UNITED STATES PATENT AND TRADEMARK OFFICE

APPLICATION NO.	FILING DATE	FIRST NAMED INVENTOR	ATTORNEY DOCKET NO.	CONFIRMATION NO.
10/605,234	09/17/2003	Chih-Han Chang	NTCP0004USA	3393
27765	7590	04/27/2005	EXAMINER	
NORTH AMERICA INTERNATIONAL PATENT OFFICE (NAIPC)			NGUYEN, KHIEM D	
P.O. BOX 506			ART UNIT	PAPER NUMBER
MERRIFIELD, VA 22116			2823

Office Action Summary	Application No. 10/605,234	Applicant(s) CHANG ET AL.	
	Examiner Khiem D. Nguyen	Art Unit 2823

DETAILED ACTION***Continued Examination Under 37 CFR 1.114***

Replacement Sheet

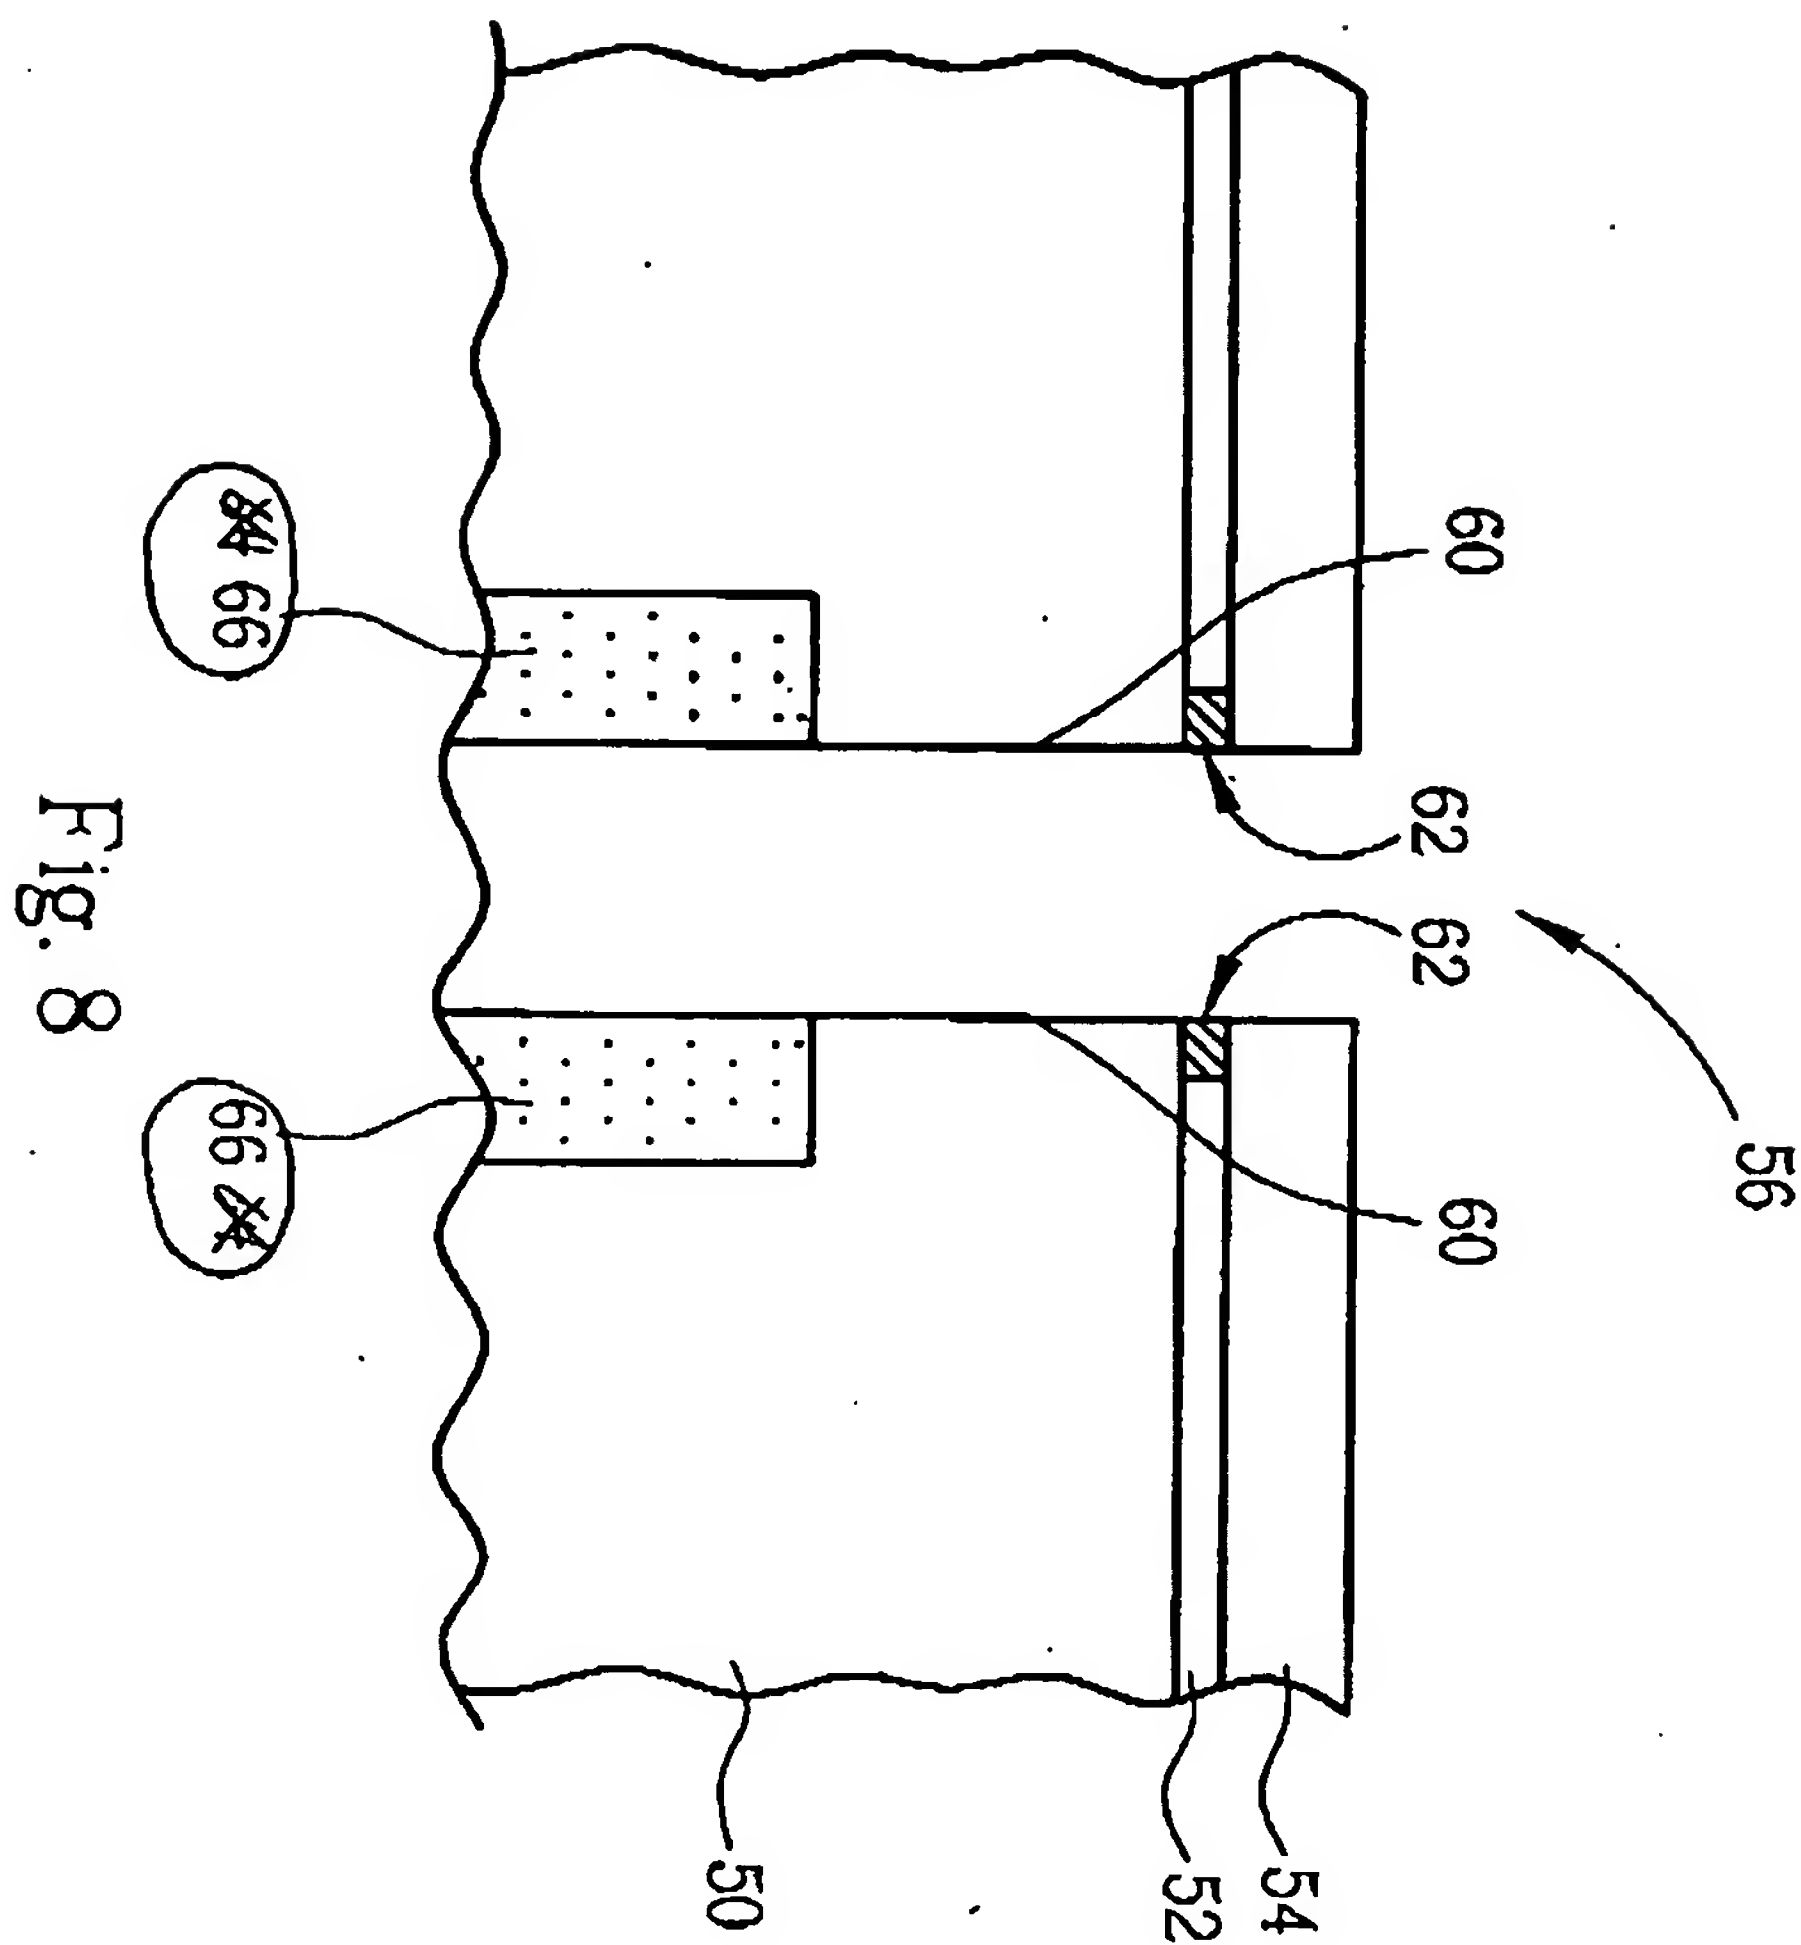
Figs.7 and 8 have been redrawn to change the numerals "64" of the doped region to "66" as shown in the encircled area of the attached "Annotated sheet". The applicant had mistakenly used the numeral "64" to refer to two different elements, and this error has been corrected. No new matter is introduced by the above amendments. Consideration of the proposed amendment to the drawings is politely requested.

Approved
